Reference: Division of Facilities Construction and Management
New North Ogden Liquor Store and Demolition And Replacement Of The
Ogden (Patterson Avenue) Liquor Store
DFCM Project Nos. 04242030 and 04180030

Subject: **Addendum No. 4**

Addendum No. A04

**New Harrisville, Ut Liquor Store
Department of Alcoholic Beverage Control
433 North Main Street, Tooele, Utah
DFCM Project No. 04242030**

9 SECTION AT OFFICE PLATFORM
SCALE: 1/4" = 1'-0"

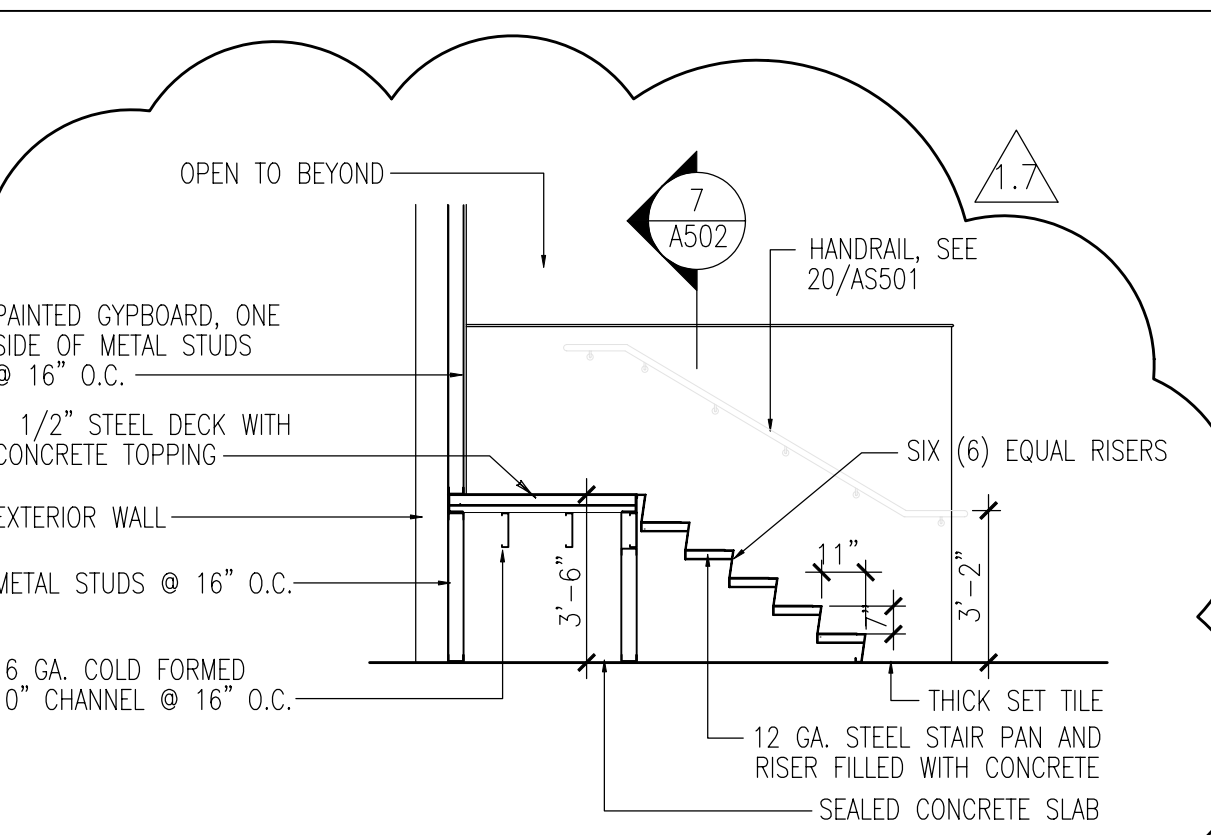
- 1.2 Dimension of the wall at the office has been added and clouded on Section 9/A101.
- 1.3 The wall near Door 09 has been dimensioned for location and length and clouded.

10 SECTION AT OFFICE STAIR
SCALE: 1/4" = 1'-0"

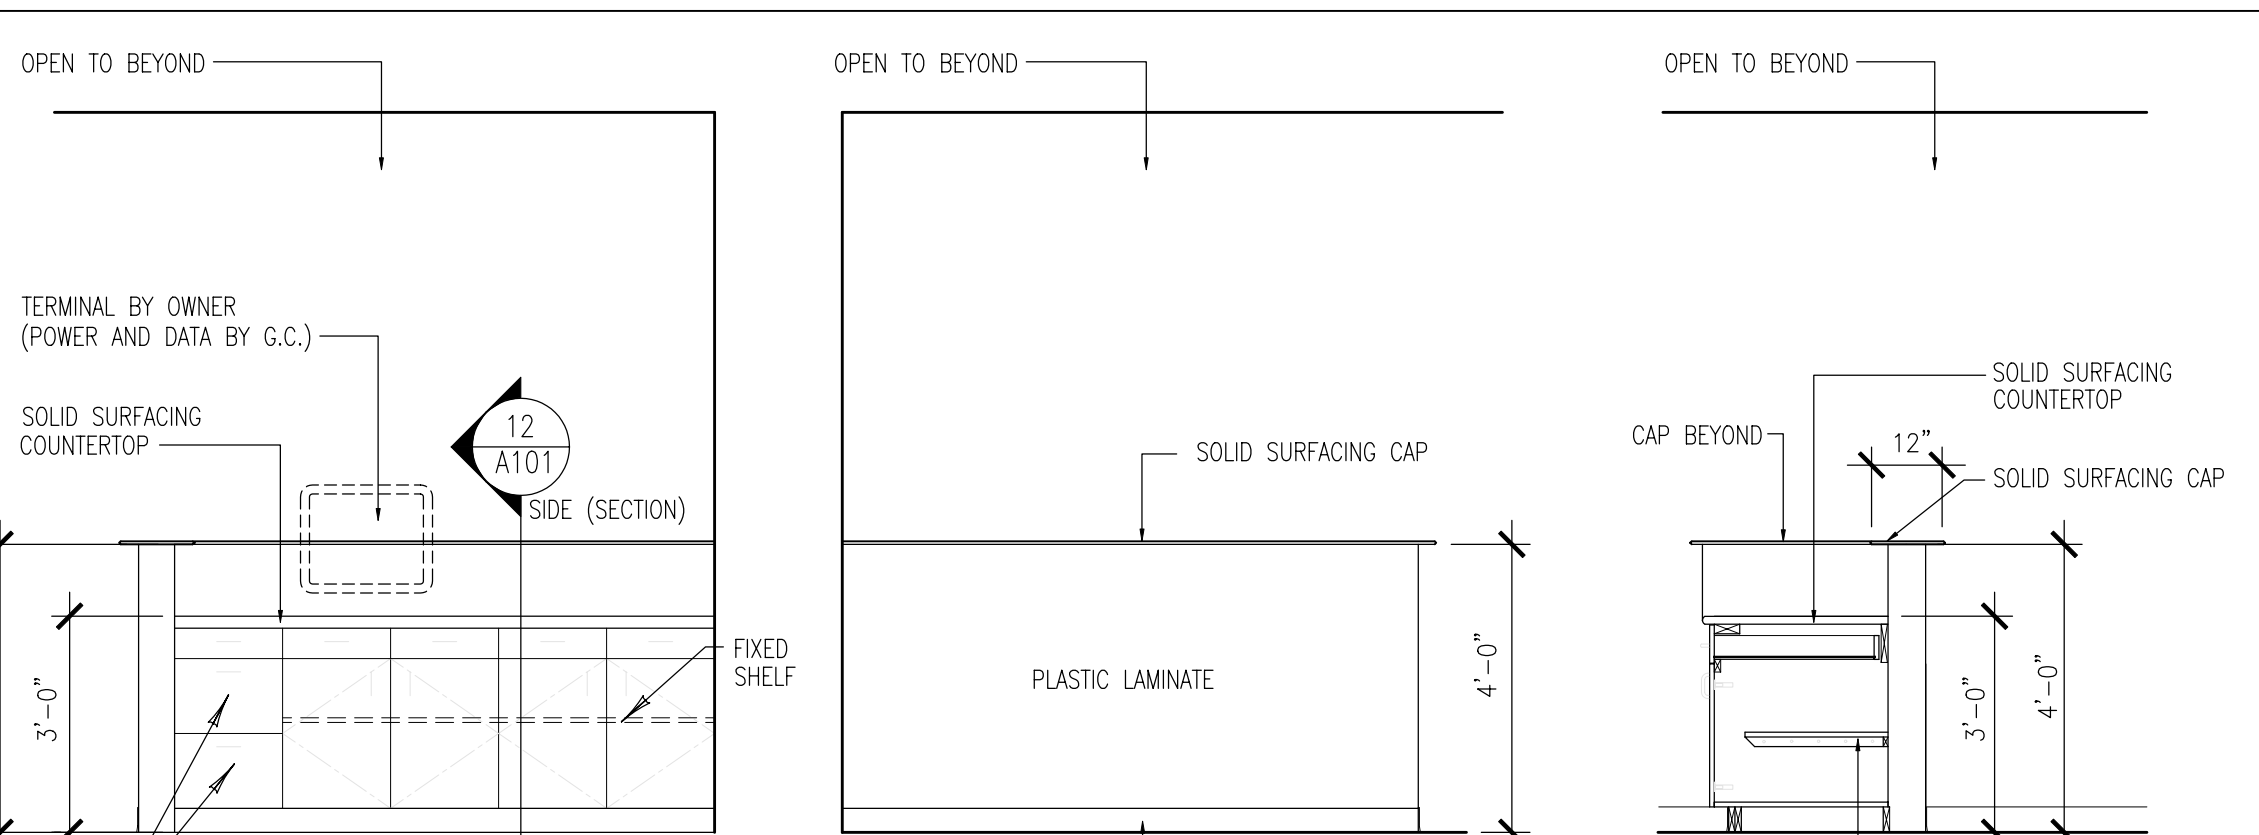
- 1.6 Wall Type 1 and its description has been added and the applicable walls have been tagged on the floor plan.
- 1.7 Section 10/A101 has been modified.

FLOOR PLAN
SCALE: 1/8" = 1'-0"

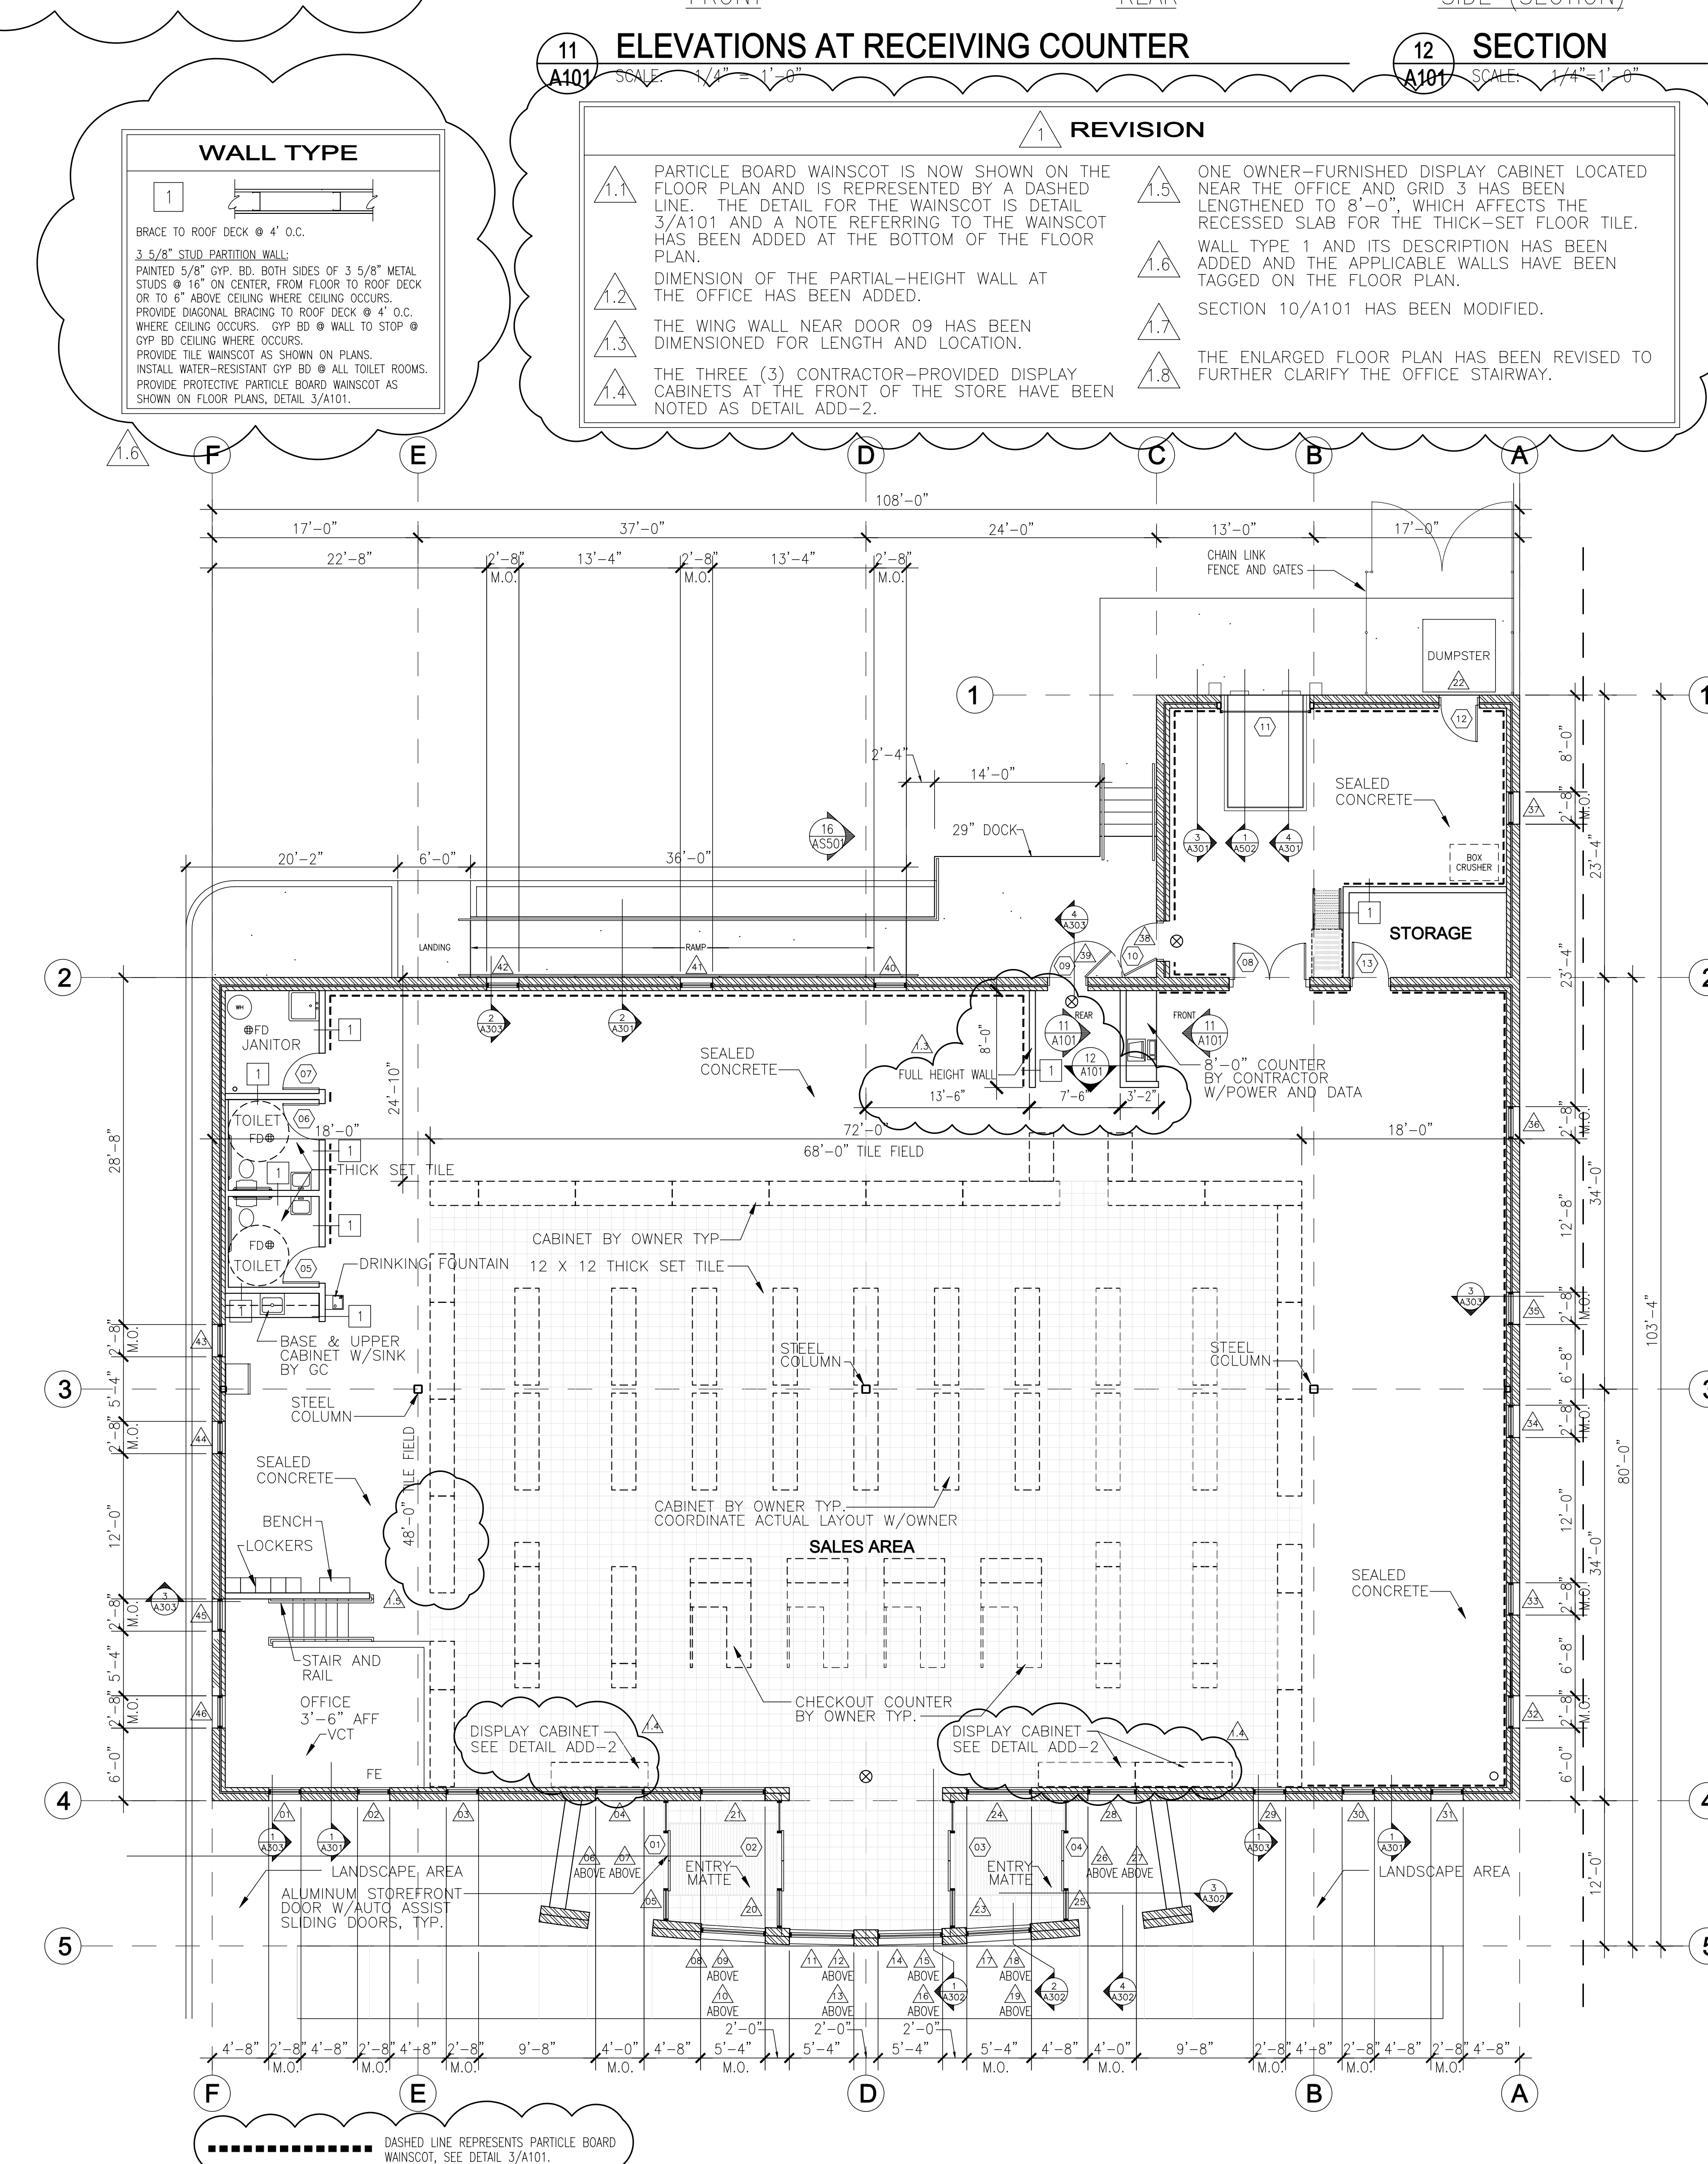
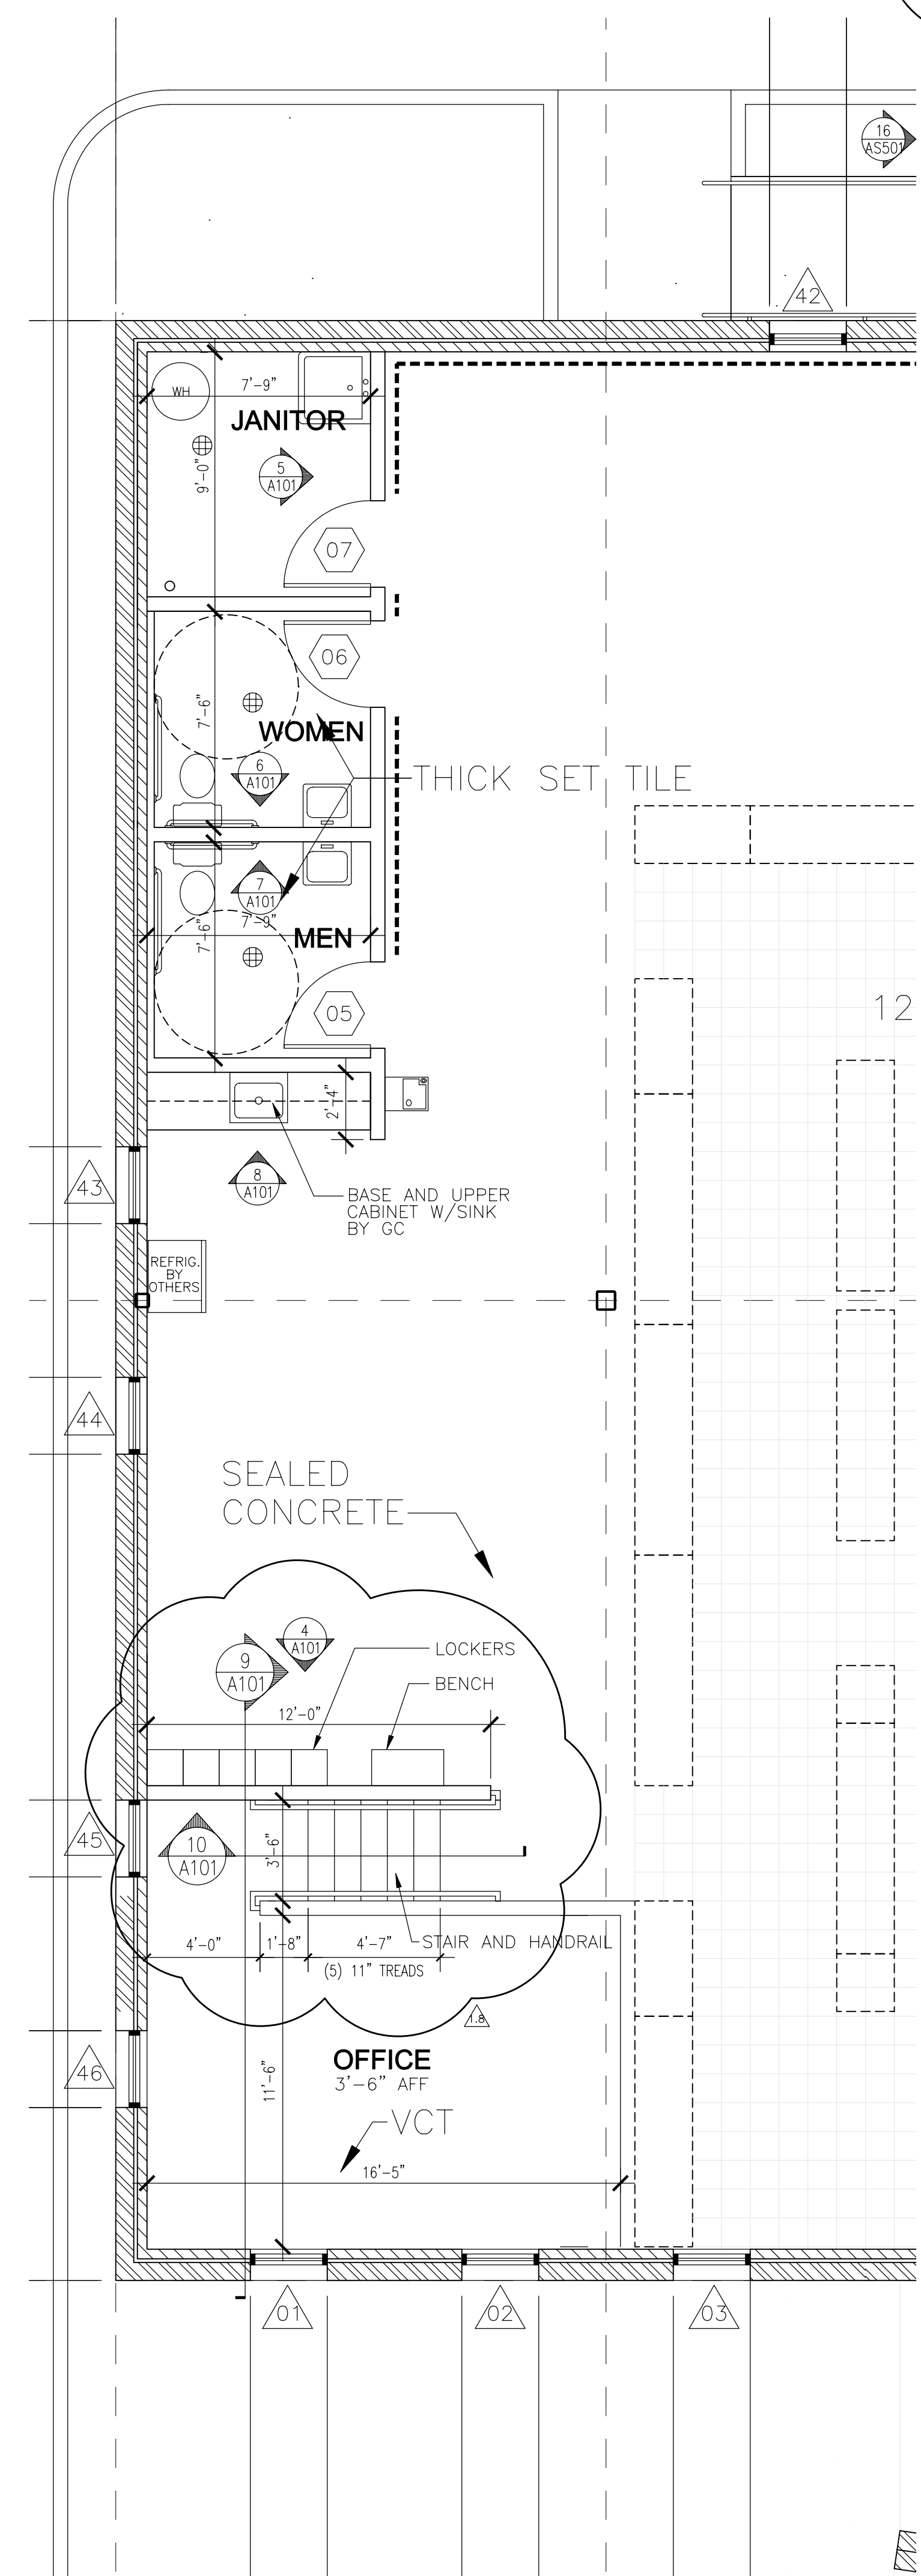
Drawing A101 has been re-issued with the following changes:

- 1.1 Particle board wainscot is now shown on the floor plan and is represented by a dashed line. The detail for the particle board wainscot is Detail 3/A101 and a note referring to the wainscot is has been added at the bottom of the floor plan and clouded.

- 1.4 The three (3) contractor-provided display cabinets at the front of the store have been noted as Detail ADD-2 and clouded.
- 1.5 One owner-furnished display cabinet located near the office and near Grid 3 has been lengthened to 8'-0", which affects the recessed slab for the thick-set floor tile. The cabinet and location have been clouded.

15 HANDICAP PARKING STALL AND ACCESS AISLE DETAIL

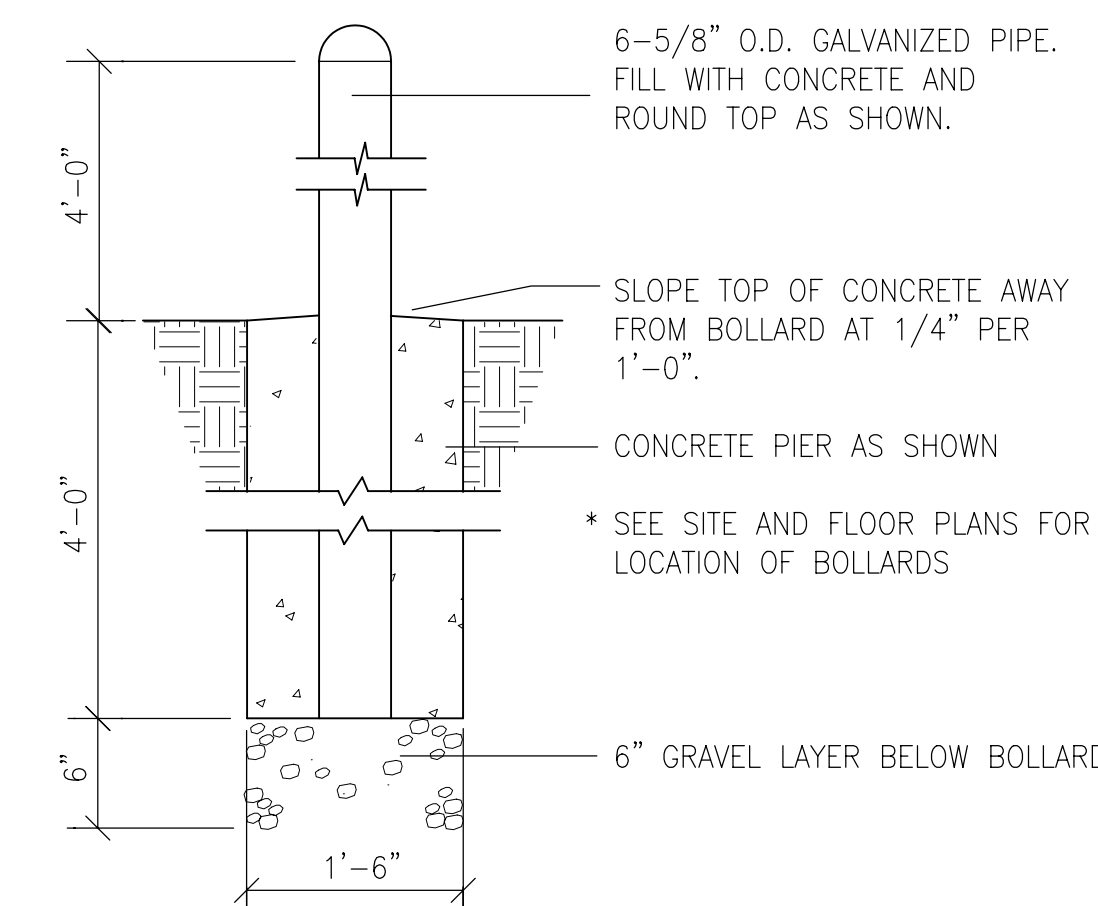
- 1.1 Detail 2/AS501 has been modified and clouded to show a change in the mounting height for the Handicapped Parking signs.
- 1.2 Detail 15/AS501 has been modified and clouded to show the new access from the two customer handicap parking stalls to the front sidewalk of the building (see Drawing AS101, note 1.1, above).
